# Access Compliance Report

## Public Rights-of-Way

Intersection ID: 53096	Main Street: ROBERT_IRWIN_DR	Cross Street: DIXIE_RIVER_RD	Location: E
ADA ID: 16E50DD2DD73	Ramp Type: PerpDiag	Initial Pass/Fail: Fail	Overall Compliance: No
		Severity Score: 8.75

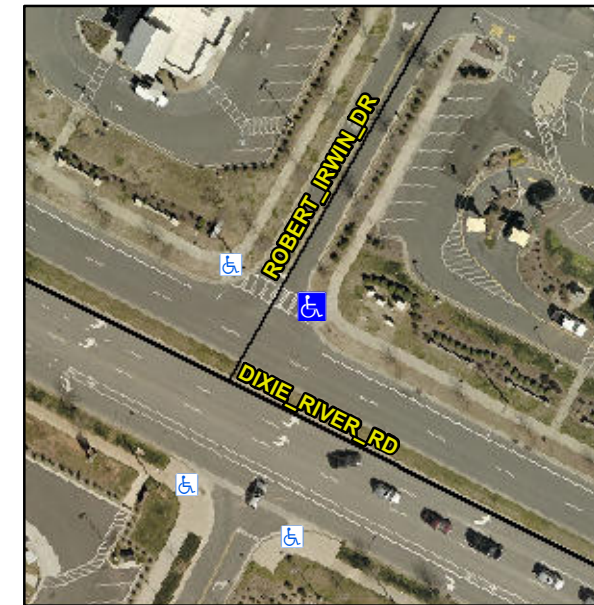
**Not Found, R304.5.1**

Compliance	Description	Data	Compliance	Description	Data
N/A	Ramp Length (in)	95.0	Yes	Ramp Slope (%)	6.3
No	Ramp Width (in)	44.5	Yes	Ramp XSlope (%)	0.4
N/A	Flare Type LT	N/A	N/A	Flare Type RT	N/A
N/A	Flare Slope LT (%)	N/A	N/A	Flare Slope RT (%)	N/A
N/A	Flare Traversable LT?	N/A	N/A	Flare Traversable RT?	N/A
N/A	Landing Length (in)	N/A	N/A	DWS Provided?	N/A
N/A	Landing Width (in)	N/A	N/A	DWS Contrast?	N/A
N/A	Landing Slope (%)	N/A	N/A	DWS Length (in)	N/A
N/A	Landing X Slope (%)	N/A	N/A	DWS Full Width?	N/A
N/A	Landing Curb? (Y/N)	N/A	N/A	DWS Offset (in)	N/A
N/A	Shared Landing?	N/A			
N/A	Gutter Ponding?	N/A	N/A	Gutter Slope (%)	N/A
N/A	Gutter Lip Ht (in)	N/A	N/A	Gutter X Slope (%)	N/A
N/A	Painted X Walk1?	Yes	N/A	Painted X Walk2?	No
	X Walk 1 Direction	To NW		X Walk 2 Direction	To SW
N/A	X Walk 1 Width (in)	110.0	N/A	X Walk 2 Width (in)	N/A
	X Walk 1 Slope (%)	2.5		X Walk 2 Slope (%)	1.3
	X Walk 1 X Slope (%)	2.8		X Walk 2 X Slope (%)	2.1

**Remove & Replace Curb Ramp With Two New Directional Ramps or Equivalent.**
